**FURTHER INFORMATION RESPONSE
TILE 2 - SDZ22A0018**

**IN RESPECT OF A
PROPOSED MIXED USE RESIDENTIAL DEVELOPMENT
AT
CLONBURRIS TILE 2
July 2023**

On behalf of the applicant, Cairn Homes Properties Ltd., we wish to respond to the request for further information issued by the Planning Authority on the 17th of February 2023 for a proposed residential development at Tile 2 - SDZ22A0018, Clonburris.

Figure 2.2: Net Development Areas

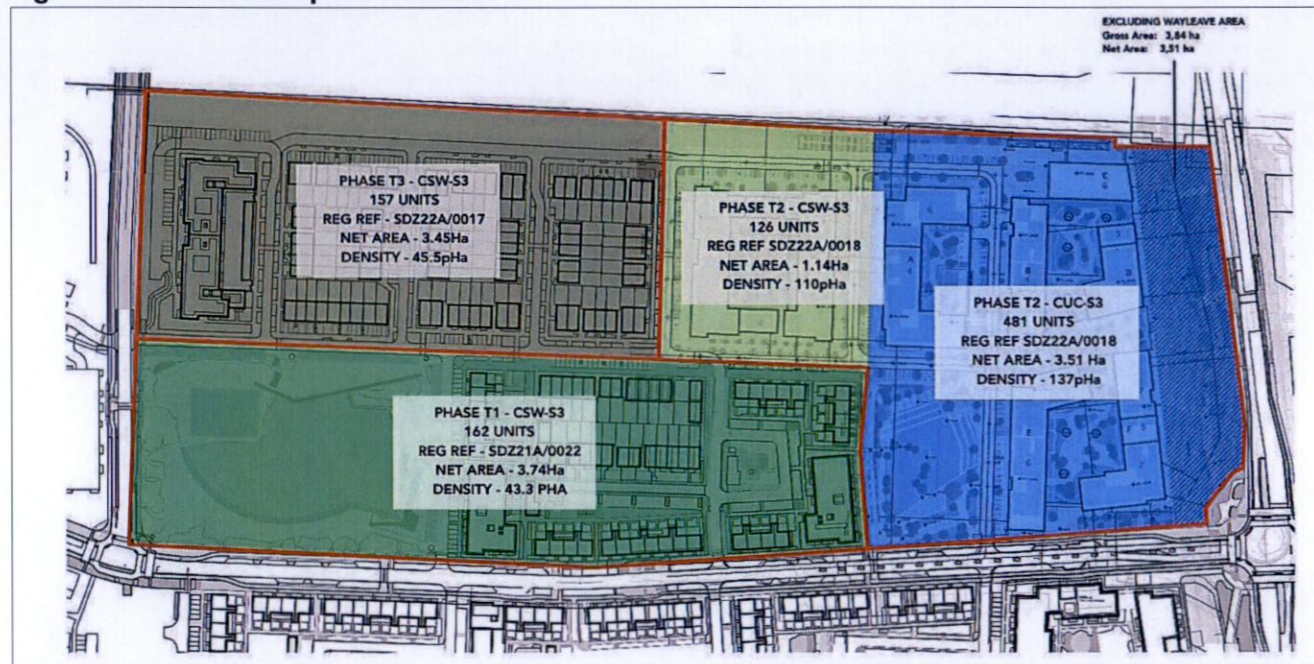
"b. The applicant is requested to set out the net development area for CUC-S3 and the net development area for CSW-S3. The applicant is requested to detail how the total net development area for CSW-S3 is met through applications SDZ21A/0022, SDZ22A/0017 and SDZ22A/0018."

In response to this item, the CSW S3 lands have been subject of 3 no. separate applications comprising Phase Tile 1 (SDZ21A/0022), Phase Tile 2 (SDZ22A/0018) and Phase Tile 3 (SDZ22A/0017) and comprise 8.33 hectares (net) in total (with a net density of 53.4 units per hectare).

Figure 2.4: Street Hierarchy and Section Locations

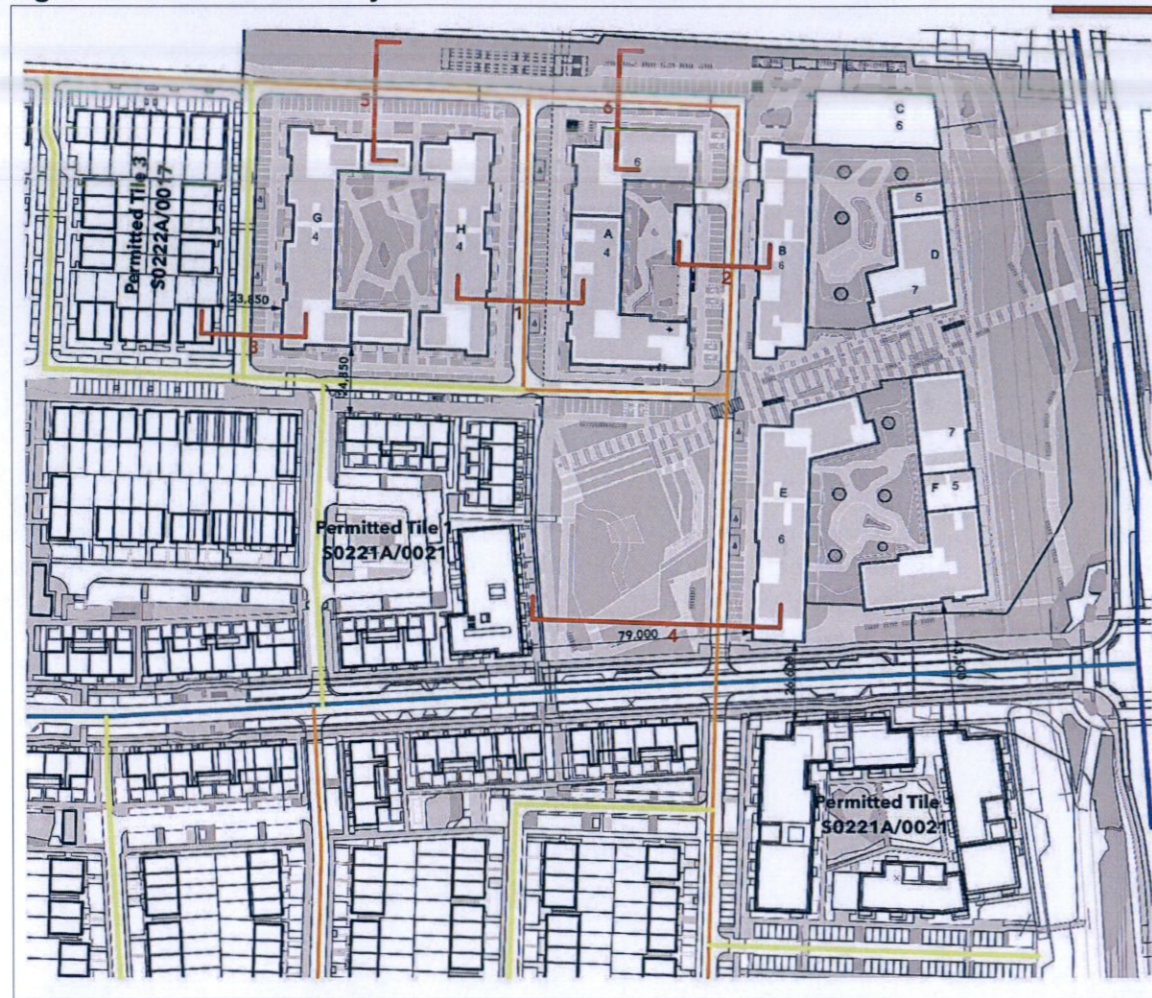
"d. Street design: The applicant is requested to provide a clear layout plan indicating: - The road typology - Width between building frontages (including areas with planning permission or under consideration applications) - Carriageway width - Footpath width - Privacy strip width (if present) - Location of street trees. Cross sections should also be provided where relevant."

We refer the Planning Authority to the enclosed ALTU architects Further Information response which includes details of road typologies, carriageway width, footpath widths and privacy strips are set out.

The site Layout Plan has been revised to include additional dimensions. The road typology is shown on the included diagram in line with the requirements of the SDZ Planning Scheme and also on a separate Movement Strategy drawing prepared by DBFL consulting engineers. The following pages include a series of 3d street cross sections with dimensions of each element to help demonstrate adherence to the requirements of the SDZ Planning Scheme.

Figure 3.1: Active Frontage Blocks E and F (Southern)

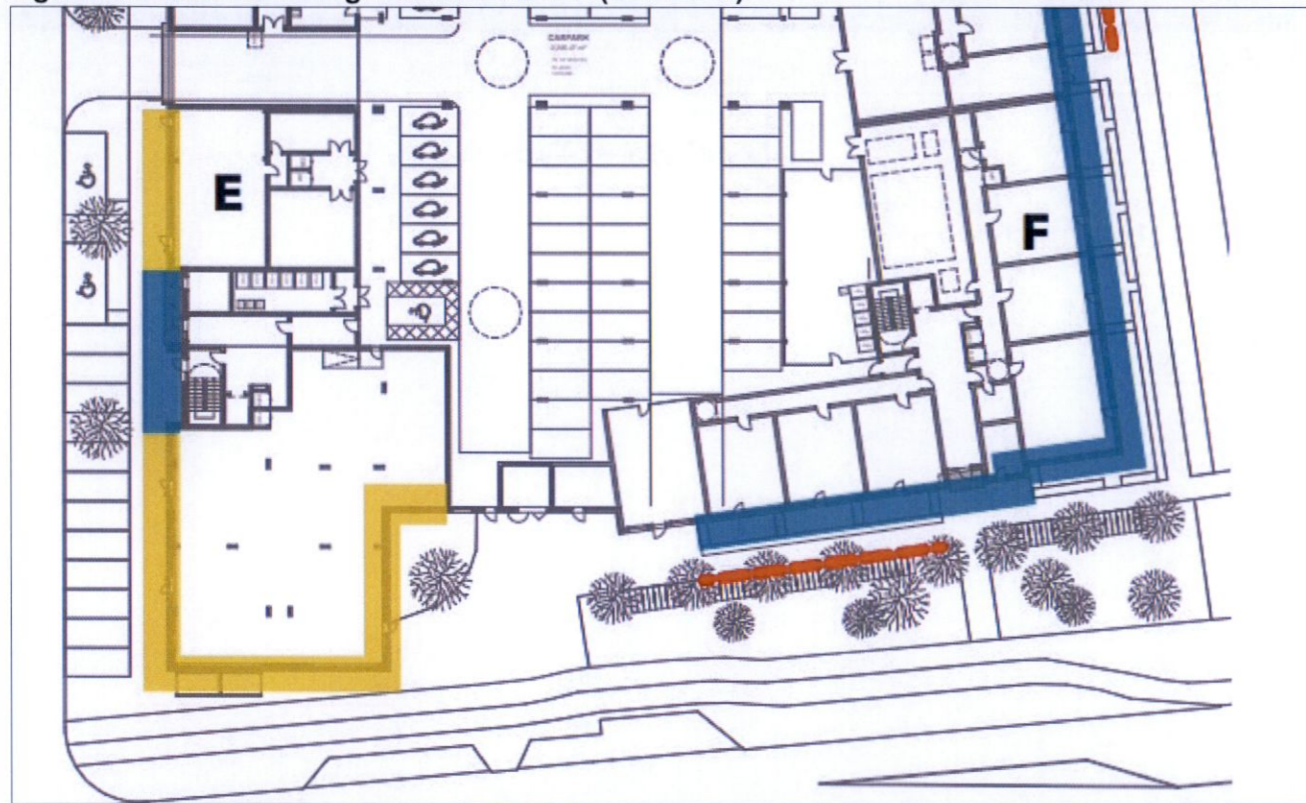
“It is noted that the scheme envisages a perimeter block to the south, where blocks E and F are located. It is noted that there is a break in this frontage at present and also that Block F is set off the southern link road. There do not appear to be any physical constraints to providing a strong frontage at this location. The applicant is requested to redesign this area to provide building frontage to the link street.”

In response to this item, the frontage along the perimeter block to the south at Blocks E and F has been increased to reduce significantly the break in frontage through the inclusion of 3 no. own door apartments. Block E and F are designed as a perimeter block fully enclosed at street level, with a narrow break on the south elevation above podium level to allow sunlight/daylight to the landscaped internal courtyard and improve the dual aspect ratio to the apartments in this location.

Figure 3.3: Heights and Road Hierarchy

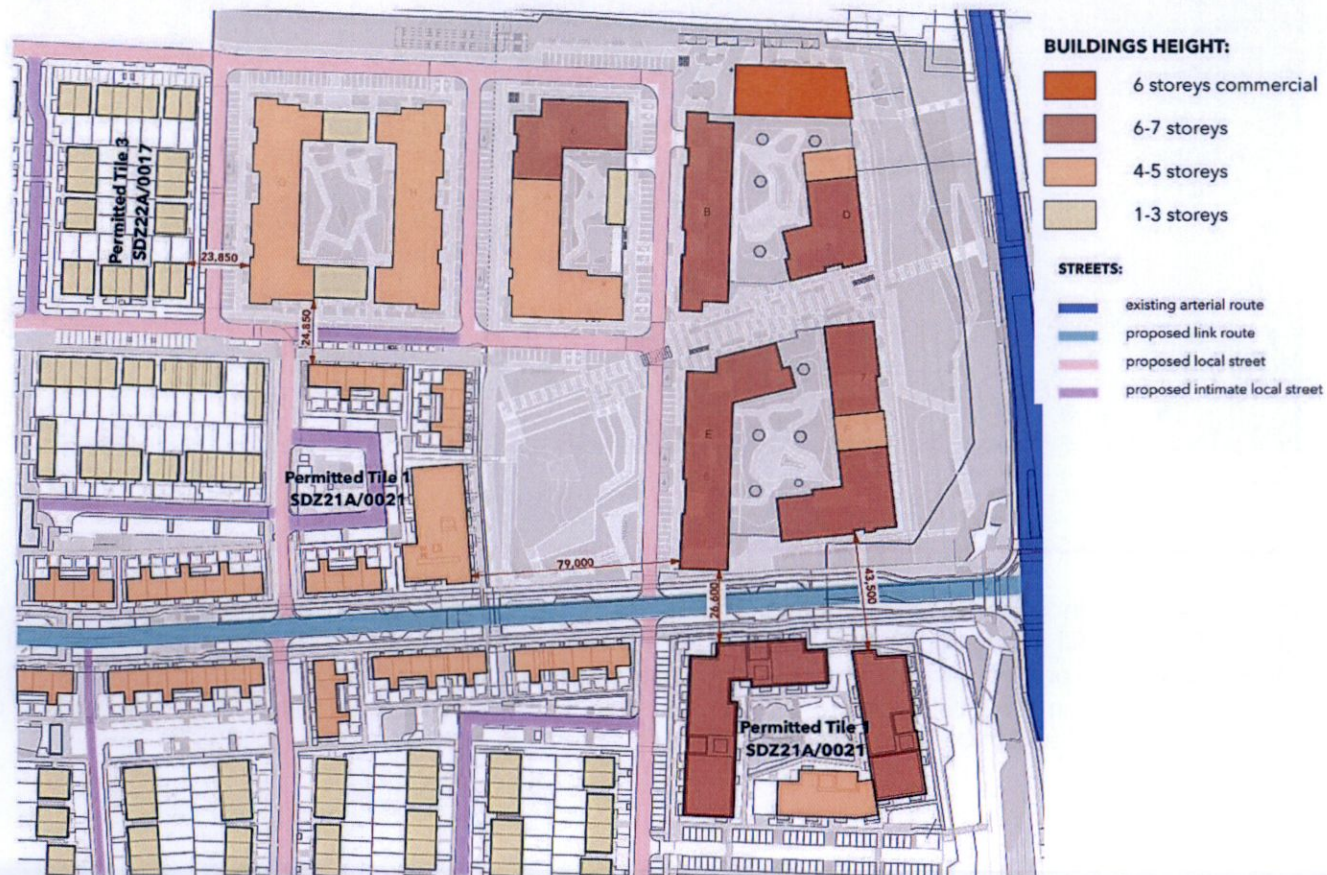
“The applicant is requested to provide a layout plan indicating how the proposed street network, frontage distances and heights fit with the permitted context or that which is in development”

In response to this item, as set out in the ALTU FIR response document, the neighbouring diagram indicates how the proposed development knits with the permitted context and how the proposed street network, frontage distances and heights respond to the SDZ Planning Scheme requirements. Proposed Tile 2 (CUC-S3) is adjacent to Tile 1 (CSW-S3) and Tile 3 (CSW-S3) which are also being developed by Cairn Homes. During the design process coordination meetings were held between the respective Design Teams to ensure that each neighbouring development will be designed with respect to heights and distances between opposing buildings in accordance with the requirements of the SDZ Planning Scheme.

Figure 3.4: Additional Active Frontage

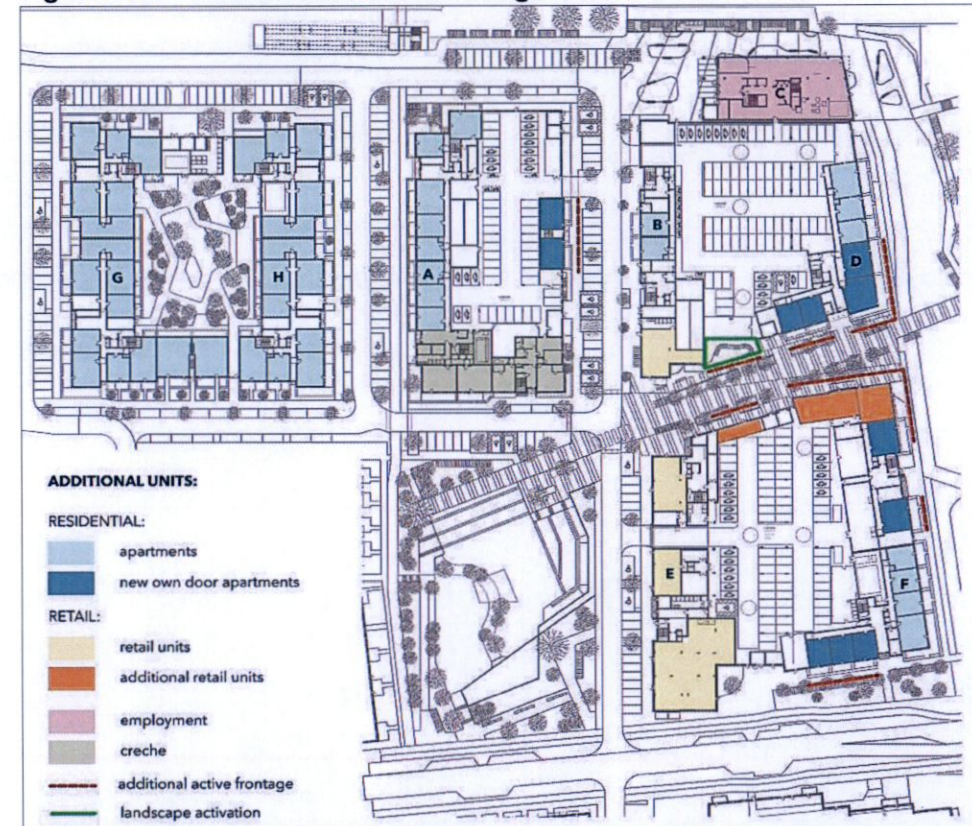
“There are concerns with the level of active uses provided along secondary shopping frontage areas and also along the southern link street frontage. The applicant is requested to provide a revised layout, which provides more appropriate uses along the secondary retail frontage and also activates the area along the link street.”

In response to this item, we refer the Planning Authority to the enclosed ALTU response document which notes that 3 no. additional retail units have been added to the norther edge of Blocks E and F fronting the pedestrian street to provide an increased cluster of retail frontage on the secondary retail street. The inclusion of these units increases the retail frontage from 887.5 sq. m to 1,150 sq. m.

Further active frontage is provided through the inclusion of ground floor own door access apartments along the southern frontage of Block D.

Figure 3.8: Active Frontage

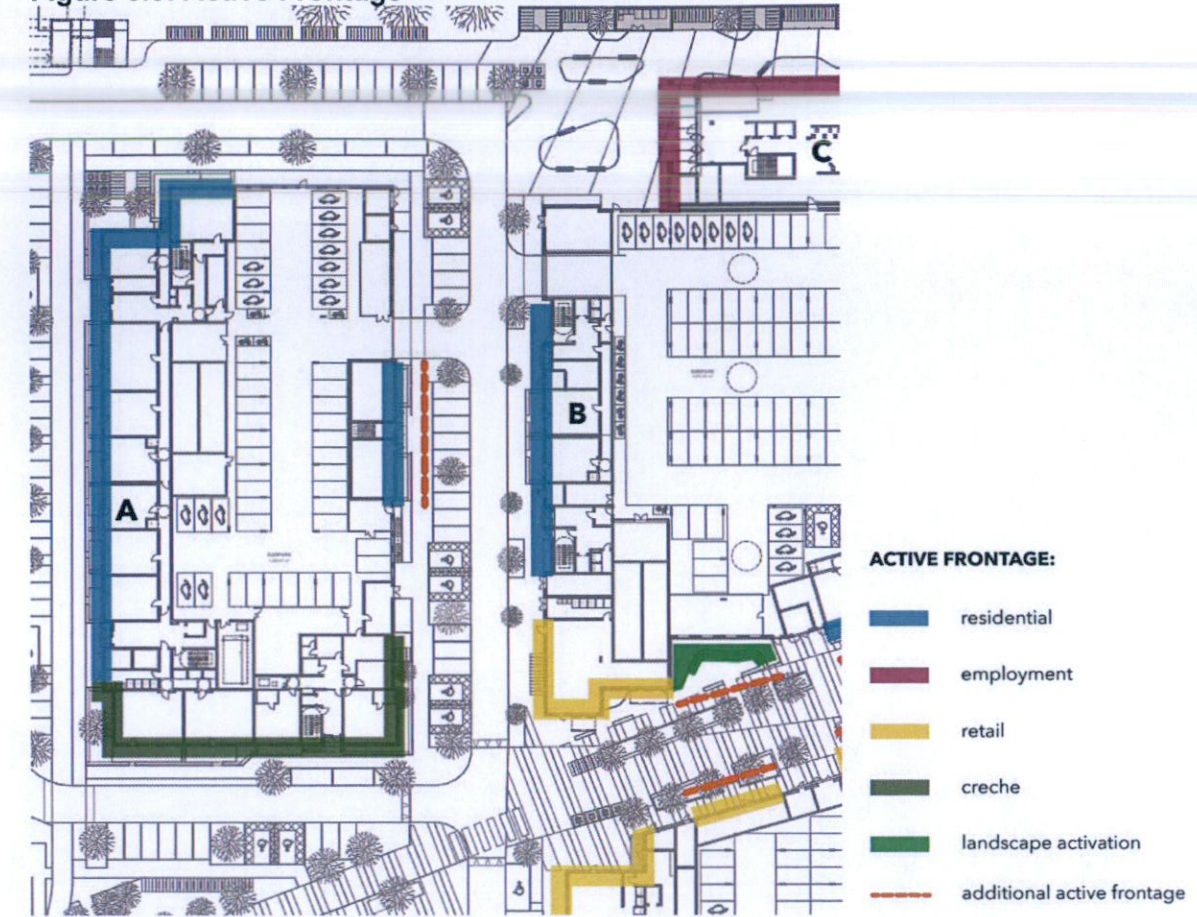
“There are concerns regarding the street between Blocks A and B, where there are few ground floor units and a significant level of plant / cycle storage etc. There are also concerns regarding the level of active uses along the pedestrianised street. The applicant is requested to consider more active uses (including the provision of more apartments) along this street.”

In response to the above, the design has been amended to include 2 no. ground floor own door apartments in Block A, with a further 2 no. above; activating the street along with including the necessary natural ventilation to the under-croft car park. The southern part of the block is activated by the creche and Block B is activated with retail and residential along with employment to the north.

Figure 4.3: Extent of Overall CUCS3

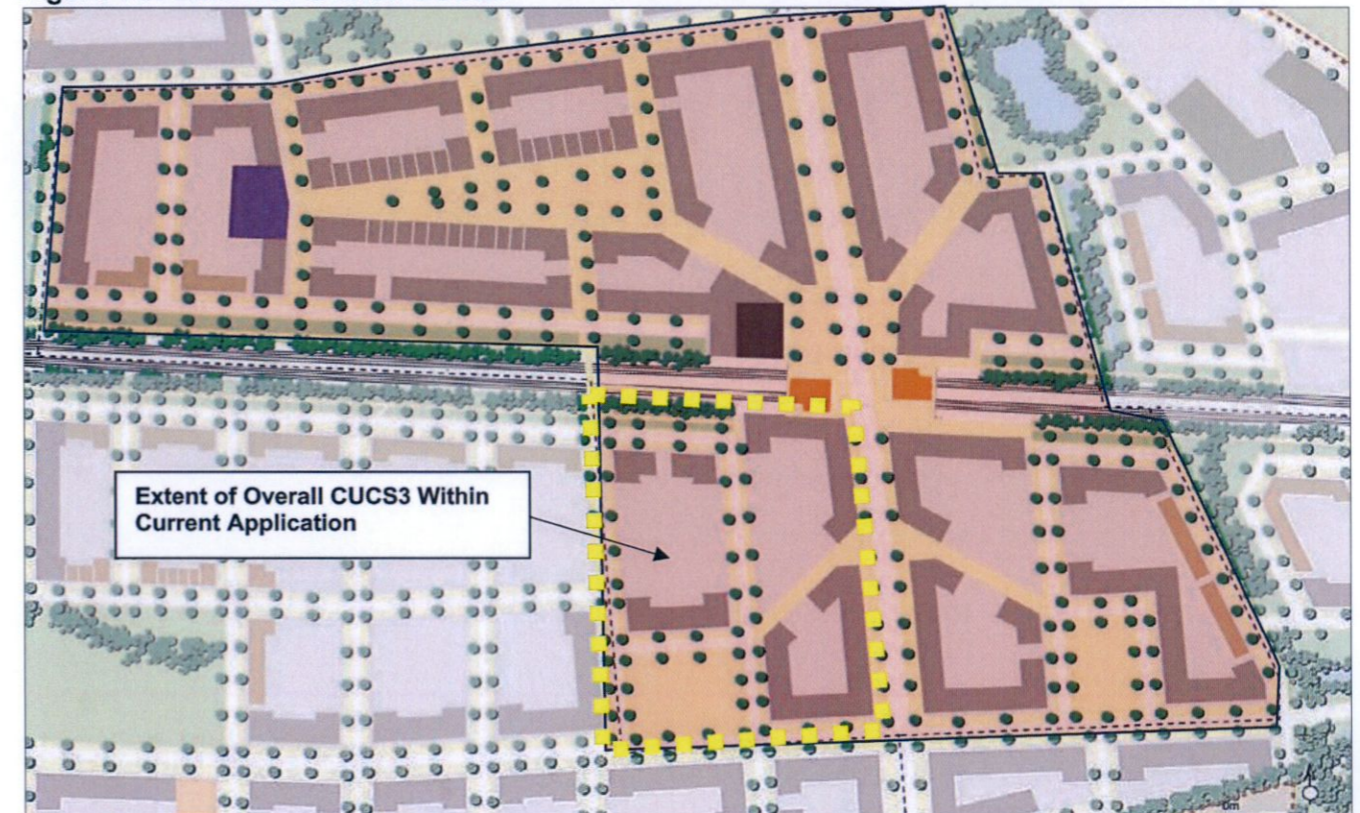
“In accordance with Section 2.5.7 Planning applications for retail development shall provide a general breakdown of retail floorspace to be provided and should have regard to the accompanying Retail Study and the indicative breakdown of floorspace into convenience, comparison and retail services. The applicant is requested to provide this information.”

Under Table 2.13.1 of the Planning Scheme the non-residential floorspace parameters for the CUC S3 sub sector are maximum retail floorspace of 1,600 sq. m and minimum non-retail floorspace of some 4,500 sq. m. The proposed development provides 4,515 sq. m of commercial/office floorspace in Block C and retail/retail services floorspace of c. 1,150 sq. m which is in compliance with Table 2.13.1 of the Planning Scheme.
